AGENDA
BOARD OF ZONING APPEALS
 Tuesday, May 17, 2016 – 5:00 PM
City Council Chambers
 125 East Avenue B, Hutchinson, Kansas

Case: 16-BZA-02

Project:	Erickson Bar/Tavern Request	DRC Meeting Date:	3/22/16; 4/26/16
Address:	1221 E 4 th Ave Hutchinson KS 67501	BZA Meeting Date:	4/19/16- tabled to 5/17/16 Meeting
Case #:	16-SUP-03; 16-BZA-02	Planner:	Jana McCarron

Project:	Erickson Bar/Tavern Request	DRC Meeting Date:	3/22/16; 4/26/16
Address:	1321 E 4 th Ave Hutchinson KS 67501	BZA Meeting Date:	4/19/16- tabled to 5/17/16 Meeting
Case #:	16-SUP-04; 16-BZA-03	Planner:	Jana McCarron

SITE PLAN/SURVEY:

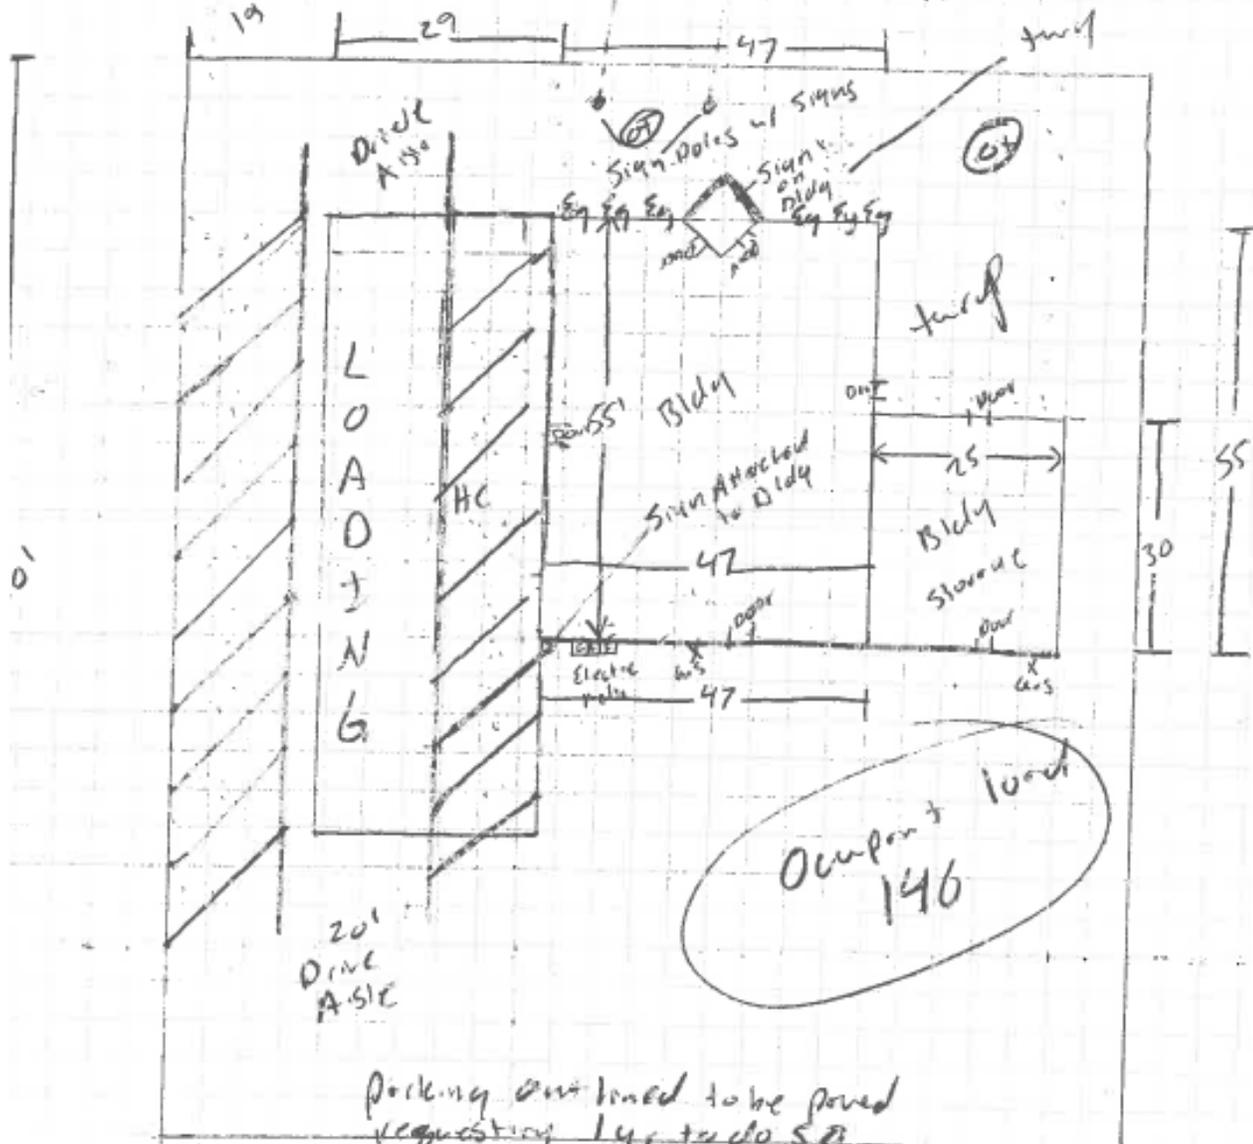
Planning staff and the Development Review Committee have reviewed the revised site plan received on April 14, 2016, for the above-referenced project. Comments are as follows:

See Development Review Committee comments dated 3/22/2016. Loading comment has been addressed. Variance requests have been made for parking and landscaping.

Submitted plan does not meet the minimum requirements of the *Hutchinson Zoning Regulations*, as follows. Approval of the Special Use Permit is contingent upon obtaining the necessary variances and extensions, as noted below.

Item	Standard	Provided	Determination
Landscaping (§27-908)	Staff estimates 52 points (disturbed area) plus 30 points (parking) are needed. All parking lot spaces are required to be no more than 75 feet from an intervening landscaped area.	Site plan contains 6 evergreen trees and 2 ornamental trees. Small evergreen trees 5-6 feet in height are 9 points each. Ornamental trees 5-6 feet in height are 9 points each. This totals 72 points. The property also contains existing turf area which will likely add up to the remaining 10 points. The minimum sizes and timing of installation should be made conditions of approval of the permit. No landscaping has been included in the parking lot areas. [16-BZA-03]	<input checked="" type="checkbox"/> Met <input checked="" type="checkbox"/> Not Met
Exterior Lighting (§27-909)	Exterior lighting shall meet the requirements of the <i>Hutchinson Zoning Regulations</i> .		<input checked="" type="checkbox"/> Met <input type="checkbox"/> Not Met

Planning staff and the Development Review Committee have reviewed the site plan received on March 10, 2016, for the above-referenced project and have the following comments:

a. Section 27-502.B. of the Zoning Regulations contains the application procedure and submittal requirements for special use permits. The sketch plan provided with the application is insufficient and cannot be approved by the Board of Zoning Appeals, as the following items are missing or are inaccurate from the drawing:

- c. **Timing of Paving.** All paving shall be installed prior to the commencement of use unless an extension on this time is approved by the Board of Zoning Appeals. The maximum time extension authority granted to the Board of Zoning Appeals is 12 months. **Failure to install the paving within the extension period (if any) shall result in revocation of the Special Use Permit.** If the applicant is requesting an extension on the paving requirement, please submit a written request either via separate correspondence or on the revised plans.

- f. **Disabled Parking Space.** One, paved van accessible disabled parking space is needed. The space is required to be a minimum of 18' long and 8' wide with an 8' accessible area striped (parallel parking spaces need to be 23' long). This space should be located as close to the doorway as possible along an accessible route. This item cannot be varied. Revised plans showing the dimensioned disabled parking space are required.

- g. **Trash Enclosure.** No trash bin is shown. If a dumpster will be used, this must be screened unless placed along the alley. If polycarts are used, no screening is required. Show dumpster and/or polycart location on the plans and screening, if needed.

- h. **Signage.** All signs shall meet the requirements of the *Hutchinson Zoning Regulations* (see 27-801) and a sign permit shall be obtained prior to installation. Existing signs need to be shown. Provide the size and location of existing and proposed signage on the revised plans.

- i. **Loading.** Section 27-701.H. of the *Hutchinson Zoning Regulations* requires one loading space for the intended use. The loading space must be a minimum of 35 feet long, 12 feet wide, have 14 feet of vertical clearance, be located 20' from the right of way and 10' from a property line. Loading areas are not allowed in the front yard. Required parking areas cannot be used for loading (overflow ones can if they meet the other code requirements). It appears that a loading area could be placed at the rear of the building. This needs to be labeled on the plans. All loading areas are required to be paved with asphalt or concrete. Show the loading area on revised plans.

1. This special use permit shall only be used for a bar/tavern in the existing structure located at 1321 E 4th Avenue;
2. An additional eight off-site parking stalls and full drive aisle shall be installed and paved with asphalt or concrete in accordance with the approved site plan within one year of the date of approval of the special use permit;
3. A certified survey shall be provided prior to paving the additional stalls and drive aisle to ensure adequate room exists for the proposed paving and parking areas; and
4. Landscaping shall be installed in accordance with the approved site plan prior to issuance of the final occupancy permit for the use.
